F6 Extension Stage 1

New M5 Motorway at Arncliffe to
President Avenue at Kogarah

Submissions report

Figure B-3 Hourly mean NO₂/NO_x and NO_x at F6 Extension Stage 1 stations (December 2017 to December 2018)

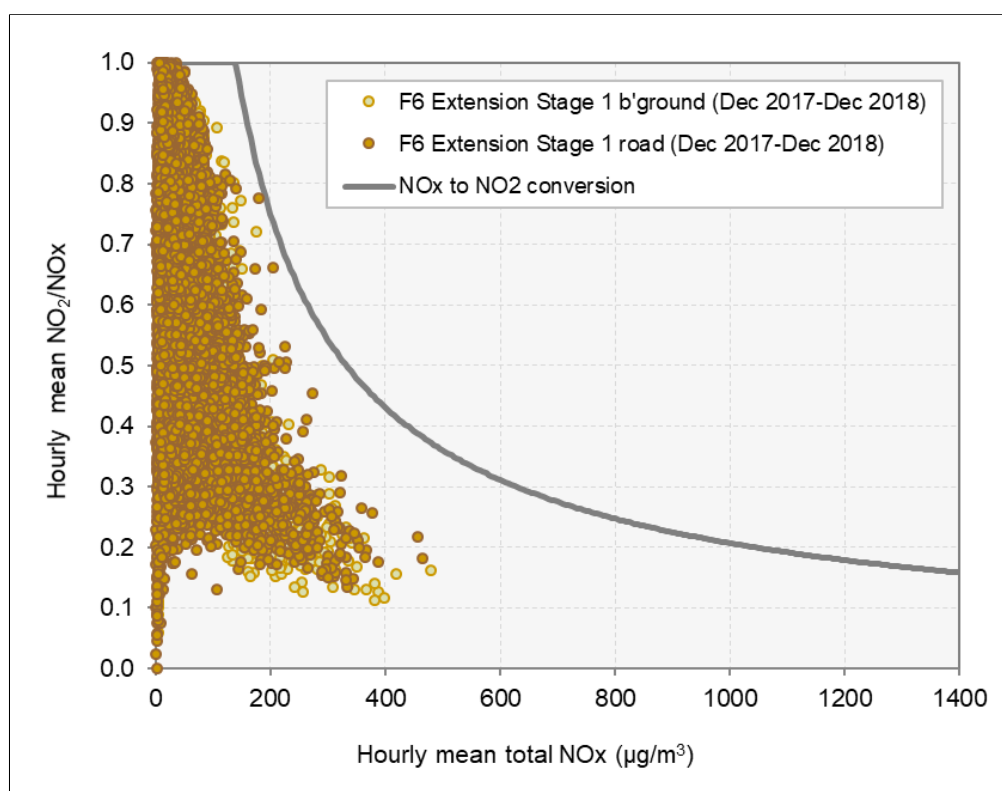
The EPA notes that Annexure H includes a model evaluation, however the model evaluation has not been conducted for the project specific monitoring locations. The EPA considers that the evaluation with project specific monitoring data should be included despite the noted difference in the time periods covered by the site-specific data. Annexure E of the Air Quality Technical Report provides the analysis conducted for the derivation of the empirical formula for NO_x-to NO₂ conversion. TA-Air notes that Figure E-7 includes project specific monitoring data collected for the two project specific stations. However, a comparison of the empirical approach with the site-specific data does not appear to be included. The EPA considers that a comparison of project specific data with the NO₂/NO_x function adopted for the project assessment should be included.

Project specific monitoring be compared against the NO₂/NO_x function adopted for the project

At the time of the air quality study for the EIS, data from the two project-specific monitoring stations (one background, one roadside) were only available for the period between December 2017 and June 2018. Data is now available up to December 2018. For the two F6 Extension monitoring stations, **Figure B-3** shows the hourly mean NO_x and NO₂/NO_x data for the full period. It can be seen that all the measurements from the F6 Extension monitoring stations were inside the envelope of the conversion function that was used in the air quality assessment, and this reflects the conservative nature of the NO₂ assessment for the specific area of the project.
